From: [Gary Yeadon](#)
To: [Light Valley Solar](#)
Subject: Re: Light Valley Solar - Clarification on Deadline 3 submissions
Date: 06 October 2026 21:48:46
Attachments: [image001.jpg](#)
[image002.png](#)
[image003.gif](#)
[image004.png](#)
[image005.png](#)
[image006.png](#)
[image007.png](#)

Light Valley Solar — Development Consent Order (DCO)

LIGHT VALLEY SOLAR NSIP

Project Reference: EN010143

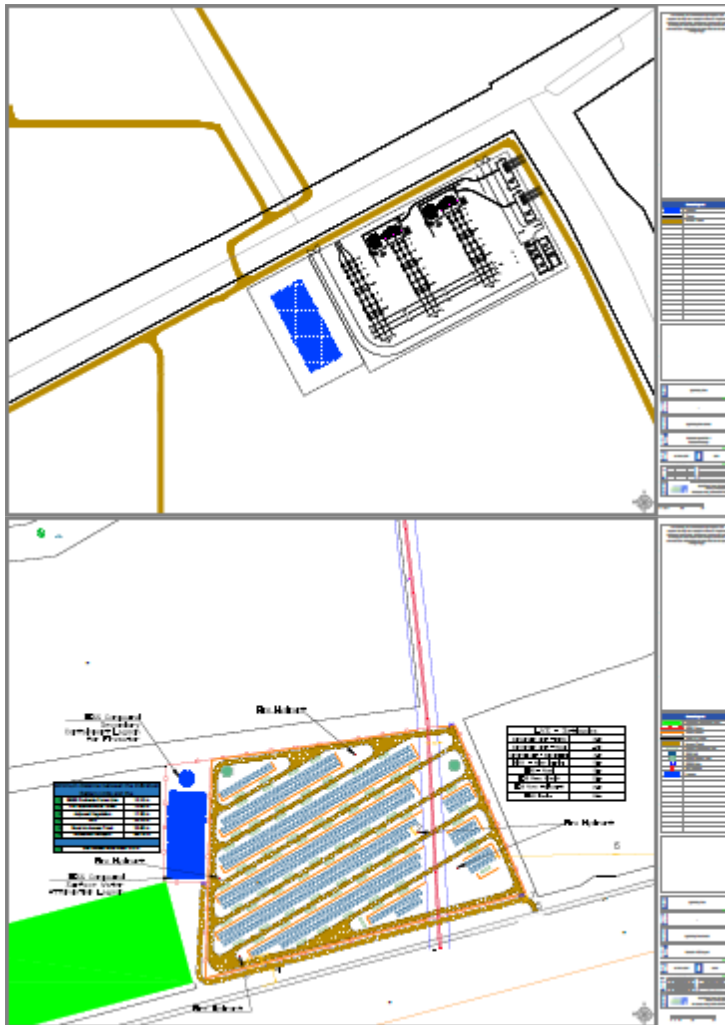
There are some Engineering Drawings available that need reworking to add vital dimensions required.

There is also a requirement for a completed Bill of Material for each site to assess the amount of avoidable disruption due to material distribution.
